Oregon Public Library Building Committee Meeting Agenda

7. **Discussion Items**
 - a. Update on New Library Project Budget, Status & Preliminary Timeline (Subject to Change)
 - b. Project Background
 - c. Review of Conceptual Design (8/19/2019)

Re: Oregon Public Library Pedestrian Crossing Evaluation
Village of Oregon (Village), Wisconsin

MEMO

Table 2. TSS reduction is over 80% for the site. A three-inch orifice was modeled as the primary outlet device.

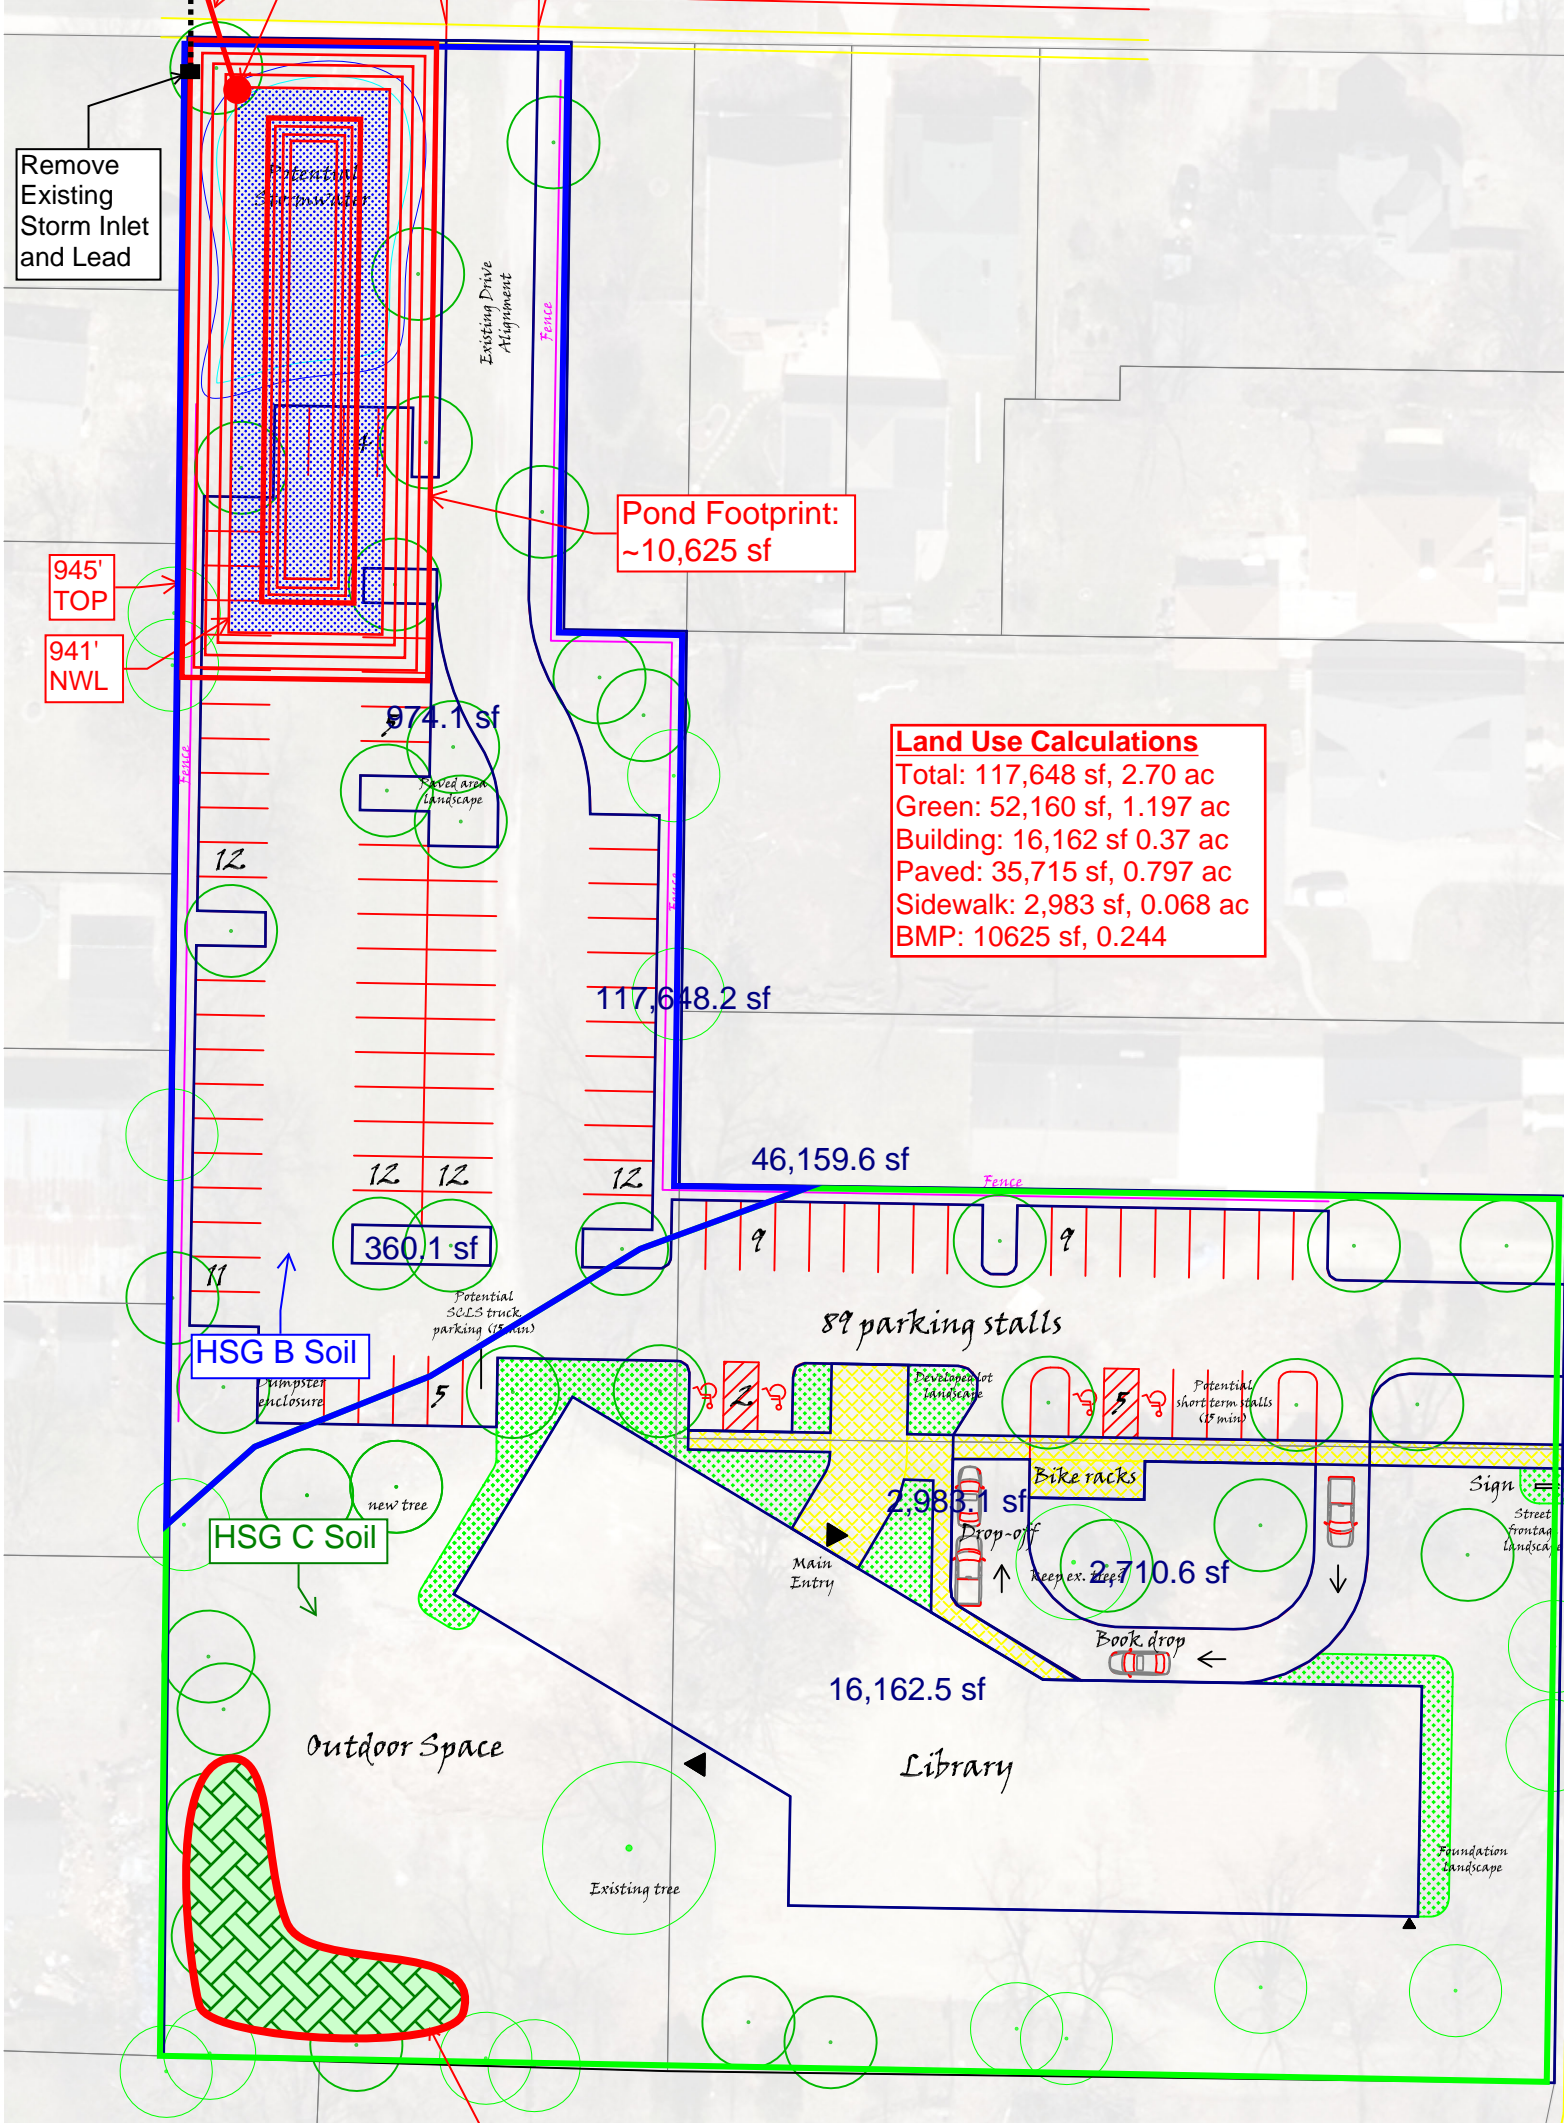
The concept develop plan offered an area for potential storm water in the northwest corner of the site. This is the obvious location for a storm water facility, given the drainage pattern of the site and its proximity to existing storm sewer on Johnson Street. In order to meet both the peak rate and water quality, a wet pond facility was sized for this area.

The existing storm sewer through Johnson Street is fairly shallow. This limits the amount of active storage in the pond that can be achieved vertically. In order to achieve adequate storage, the pond had to be expanded beyond the limits shown in the concept development plan. Exhibit A shows the approximate size and geometry of the pond sized to meet the planning requirement. Tables 1 and 2 below summarize the results from the hydraulic and hydrologic modeling.

There are a number of ways to potentially reduce the footprint of the wet pond while still achieving the planning requirements. In this exercise, the entire 2.7-acre site was assumed to drain to the pond. To some extent, grading could be altered to convey runoff from small areas to other best management practices on site. For example, roof runoff could be diverted to a bioretention device in the southwest corner of the site. Splitting the runoff will allow the pond to require less storage volume. Another possibility would be using underground storage chambers in the parking lot to detain storm water.

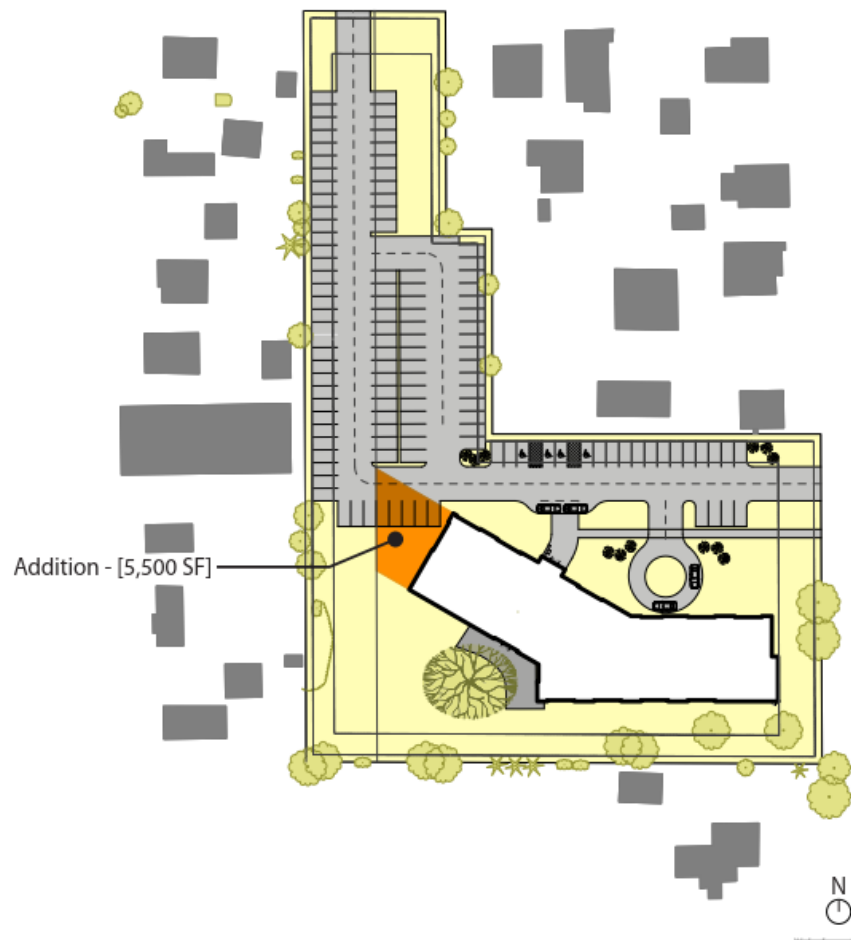
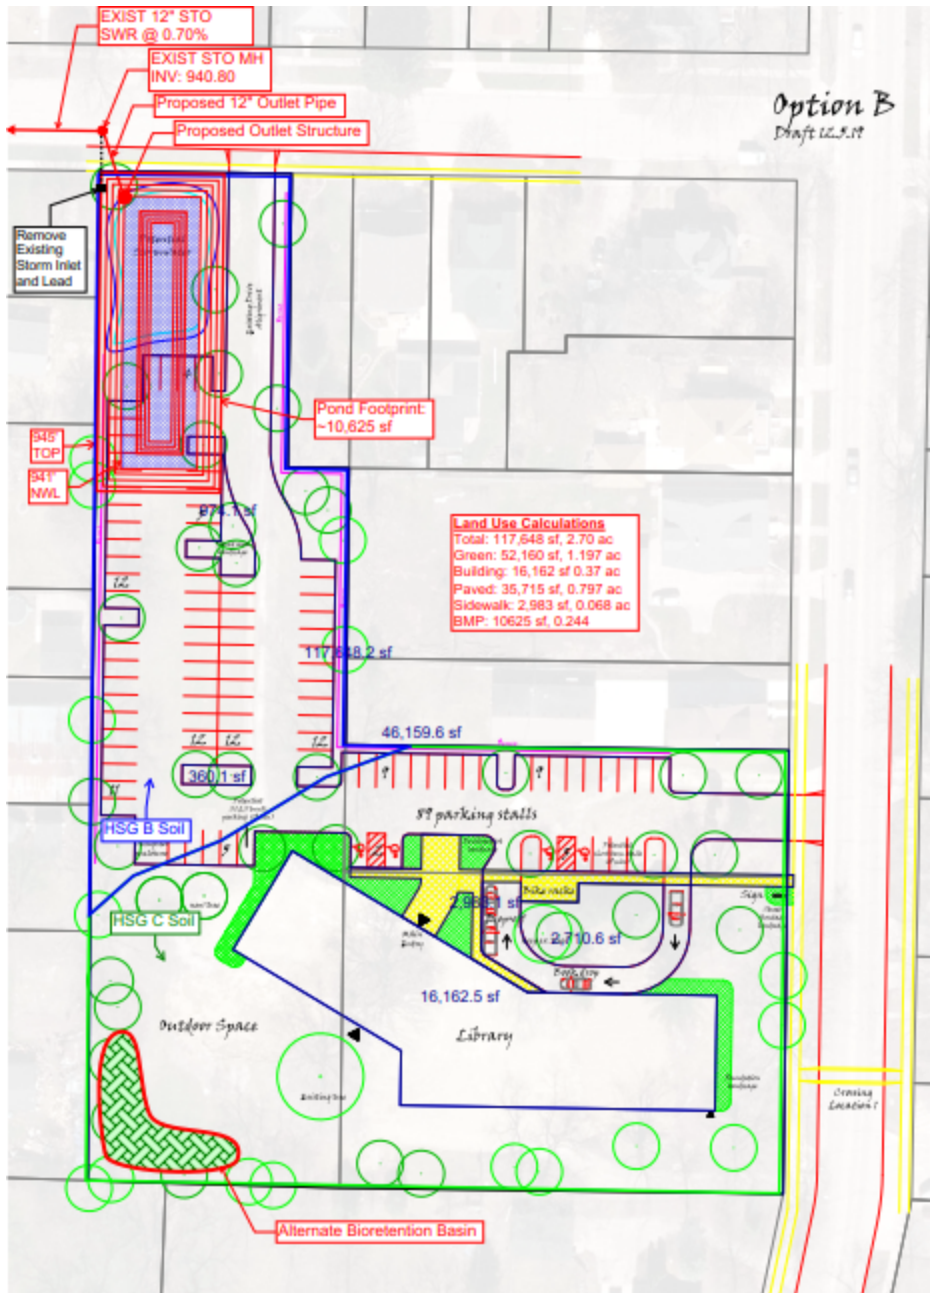
- For “indoor institutional” uses such as schools, museums, hospitals, and libraries, the Village zoning code requires one parking space for every 250 square feet, plus one space for each staff member on the largest shift. Given this calculation, the new library (which is planned to be 33,000 square feet and have approx. 15 staff working during the largest shift) would require 145 parking spaces on-site, off-street to meet the code.

- The current library on Brook St. is 10,500 square feet with 36 off-street, dedicated parking spaces. While the current library does have plenty of nearby on-street parking, this number would not meet our code today- around 50-55 parking spaces would be required if the current library was built today.

- In the Planned Development zoning process, the Planning Commission does have the ability to allow “flexibilities” from the zoning code during the General Development Plan (GDP) review process. Given their history of allowing reduced parking requirements on other developments, we feel that the Planning Commission may support a reduction in the parking requirements for the new library by 10-20%, bringing the need for on-site parking spaces down to 115-130 or so. It is important that the Village of Oregon hold itself to similar standards and “flexibilities” that we hold to private developers.

- An initial analysis of the necessary stormwater management pond size was done by the Village engineer, Ruekert-Mielke, this fall. Their initial review showed the stormwater management pond taking up a large portion of the northern end of the site and eliminating some parking spaces that were planned to go in that location.

- The competing desires of meeting parking requirements on the site, providing on-site stormwater management, and maintaining a landscaped buffer for the neighborhood all contribute to a complex site plan. One solution to these issues may be to consider acquiring adjacent property. An acquisition of adjoining property may not only allow an additional access point to and from the site, but would also add space for more on-site, off-street parking.
